# Proposed Remedy to i-209

G. Zimmerman

11 September 2017

Figure 145-37—Interconnect model, cross-connect model, and midspan insertion configuration

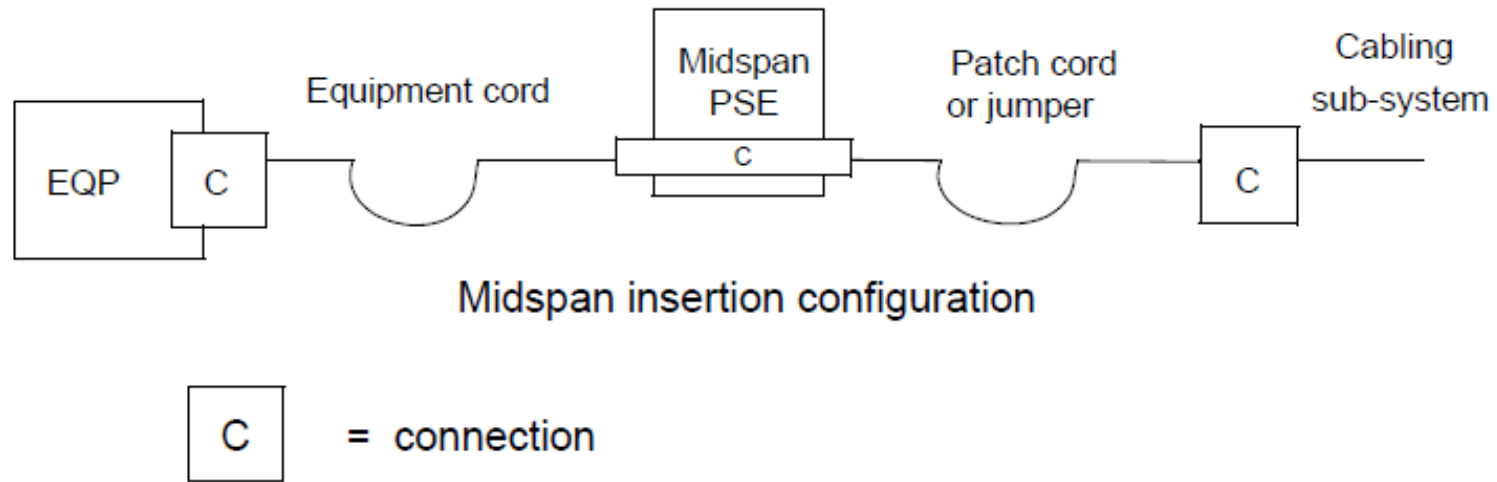
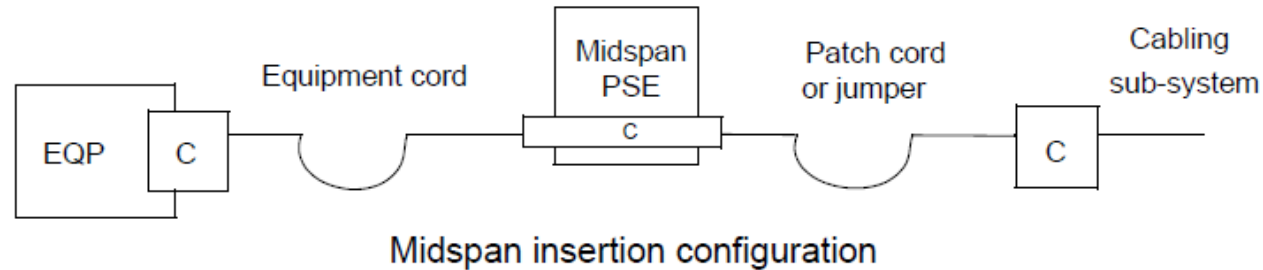
- In going from Category 5e to Category 6 (including 6a), connector insertion loss specifications in TIA-568 went from  $0.04 \cdot \text{SQRT}(f)$  to  $0.02 \cdot \text{SQRT}(f)$ .
- A Midspan PSE replaces 1 connector with 2 connectors and contains magnetics, and needs to create margin to meet the slim insertion loss limits on connectors.
- The principle of having a midspan replace a connector in the channel worked well for Category 5e connectors where the connector insertion loss allowed some margin. Implementors could meet this spec by using higher quality Cat 6 connectors on their midspans.
- 10GBASE-T link segments are based on Cat 6 connector insertion loss, reducing the opportunities to create the margin needed for midspans.

# Figure 145-37 Midspan Insertion Configuration

Figure 145-37—Interconnect model, cross-connect model, and midspan insertion configuration

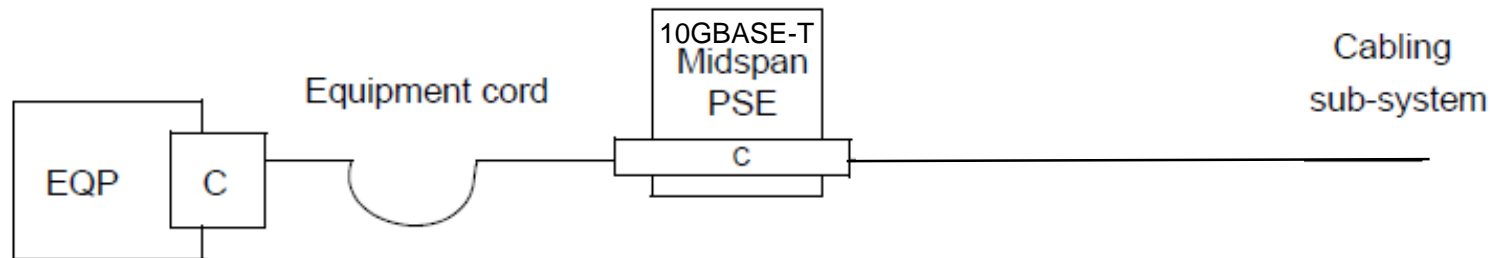
# Proposed 10GBASE-T Midspan Insertion Configuration: May replace up to 2 connectors, not one

10GBASE-T Midspan insertion configuration (when needed to meet 100m “channel” insertion loss specified in TIA)

- c) For a 10GBASE-T midspan PSDs, in meeting either of the above requirements, the Midspan PSE may be substituted for up to two connection pairs in the FD.

- c) For a 10GBASE-T midspan PSDs, in meeting either of the above requirements, the Midspan PSE may be substituted for up to two connection pairs in the FD.
